Unreliable touch control operation KD9570.0 J KD9570.0BC

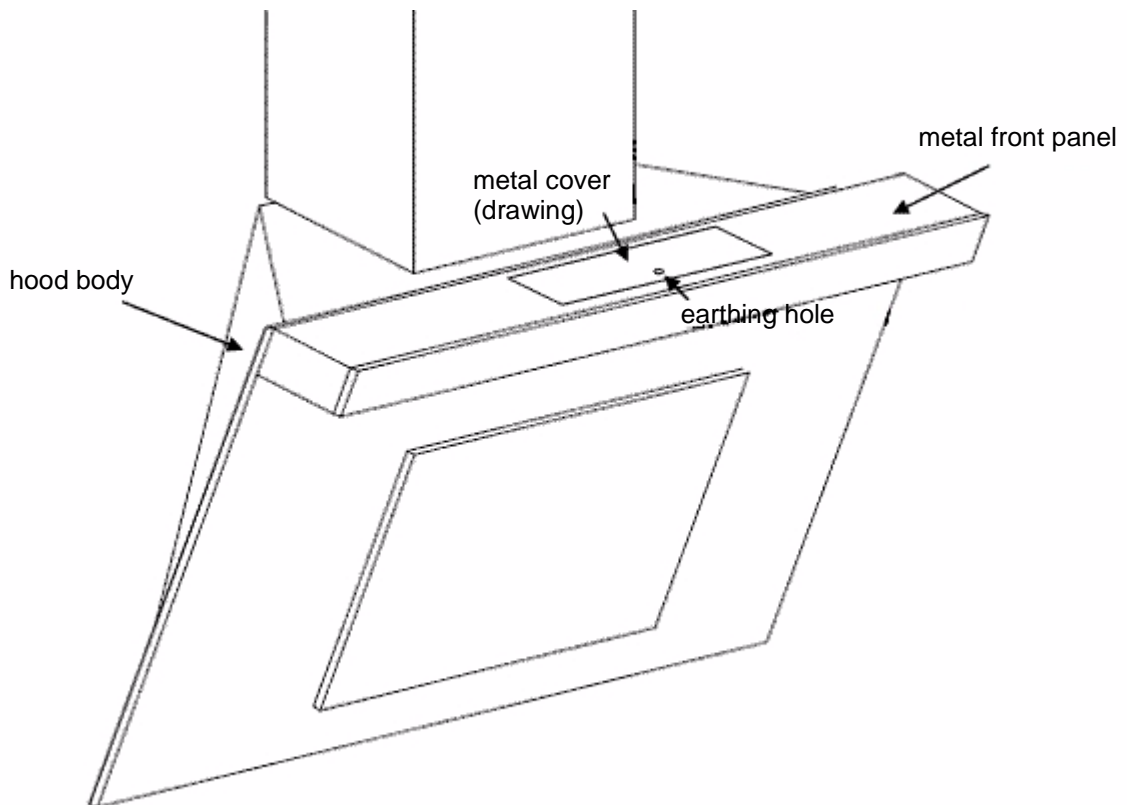
In the event of control problems with touch control **spare-part no. 543624** (code number C21213502) a check will need to be carried out to determine whether there is an electrical connection between the metal front panel and the body of the hood (check for transmission with an ohmmeter).

It is not necessary to earth the touch control; only a connection between the body of the hood and the metal front panel needs to be made if problems with the touch control occur. This relates to the potential equalisation of the touch control "metal surrounding". See illustration:

Models produced approximately as of autumn 2010 use a metal cover with an earthing hole (see the drawing), so that this error has been rectified for appliances as of autumn 2010.
